Agenda Item	8.3
Report No	PLS-98-22

Report Title: 22/03916/FUL: The Highland Council

Bught Park, Bught Drive, Inverness

Description: Erection of pavilion, refurbishment of stadium, and replacement changing rooms

CLIENT	Development & Infrastructure	SCALE	As indicated
PROJECT	Bught Stadium & New Home of Shinty	DATE	10/06/22
CONTACT	Colin Henderson	DRAWN BY	AM
DRAWING TITLE	Proposed Site Plan	CHECKED BY	CH
PURPOSE OF ISSUE	Planning	PAPER SIZE	A1

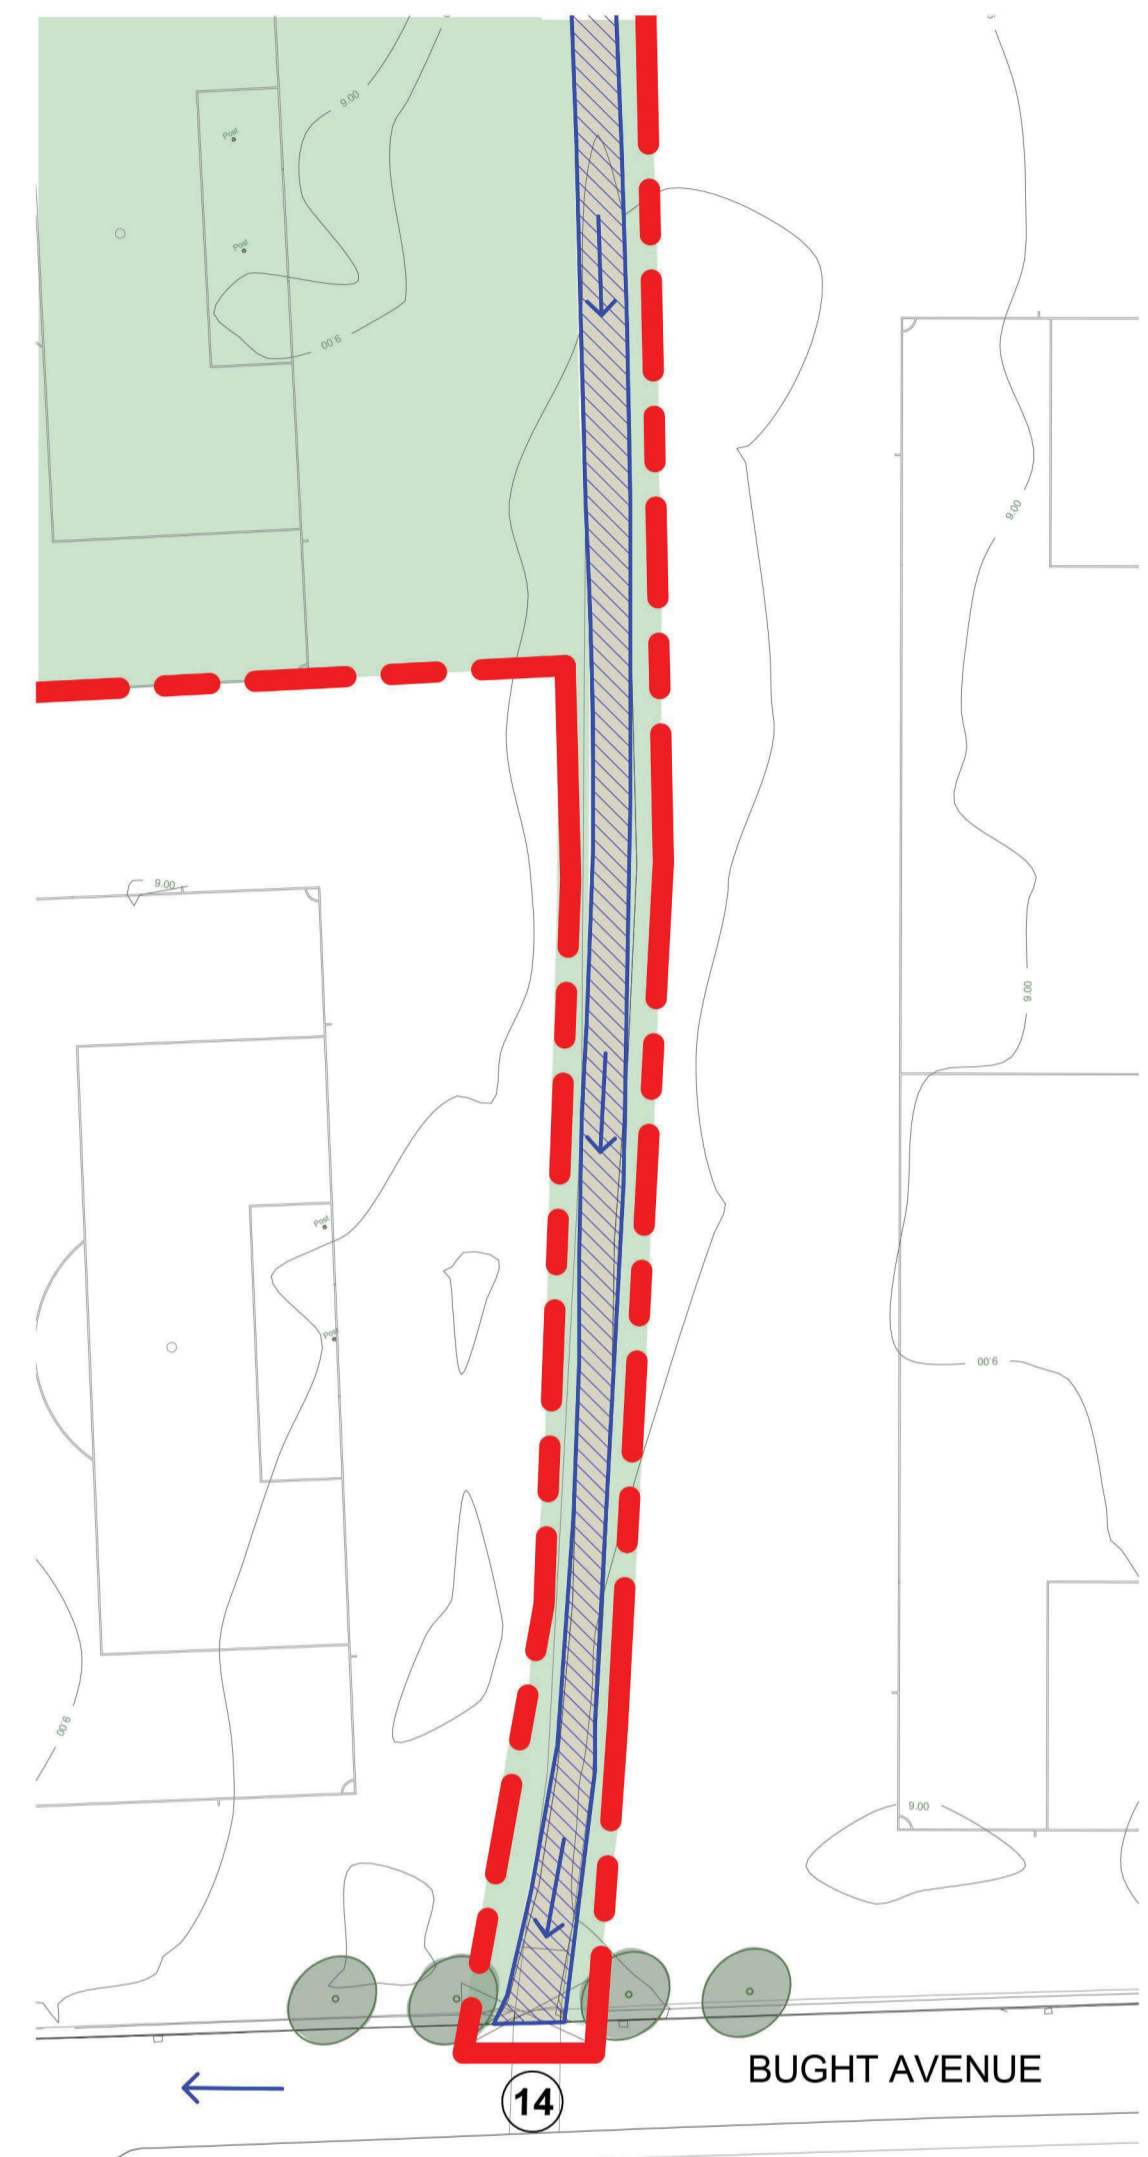
8. The 'large event vehicle exit' shown on the approved Proposed Site Plan (drawing number 0003) at its junction with Bught Avenue shall not be used until full details of measures to improve that exit have been submitted to, and approved in writing by, the Planning Authority, and thereafter implemented prior to first use as a large events exit point.

15. The extended coach/car parking area shown as 'Plan Key 7' on the approved Proposed Site Plan (drawing number 0003) shall only be used for events taking place at the Stadium and/or on Bught Park pitches. The 'large event vehicle exit' onto Bught Avenue referenced on the Proposed Site Plan shall only be used during large scale sporting or entertainment events requiring access to the site by coaches and/or large goods vehicles, and any such use of the large event vehicle exit will require the submission and approval of a Parking Management Plan, details of which shall be submitted at least three weeks in advance of any large scale sporting or entertainment event taking place. Following approval, all large scale sporting or entertainment events shall be managed in accordance with the approved Parking Management Plan.
